# Access Compliance Report

## Public Rights-of-Way

### (Curb Ramps)

Intersection ID: N/A	Main Street: E 8TH ST	Cross Street: N BREVARD ST	Location: E
ADA ID: 9B09AA4DFADA	Ramp Type: Perp	Initial Pass/Fail: Fail	Overall Compliance: No
Severity Score: 8.75			
Codes/Mitigation Info/Possible Solution		Field Measurements/Component Compliance

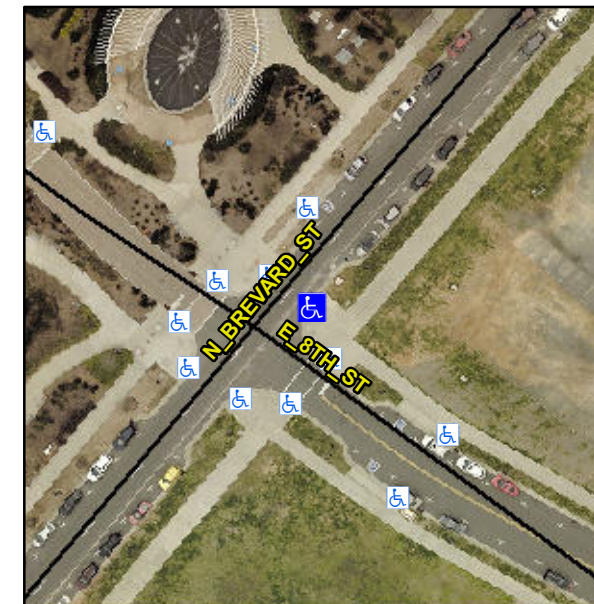
Possible Solutions:

**Remove & Replace Entire Ramp.**

PROW/ADA:

**R304.5.1**
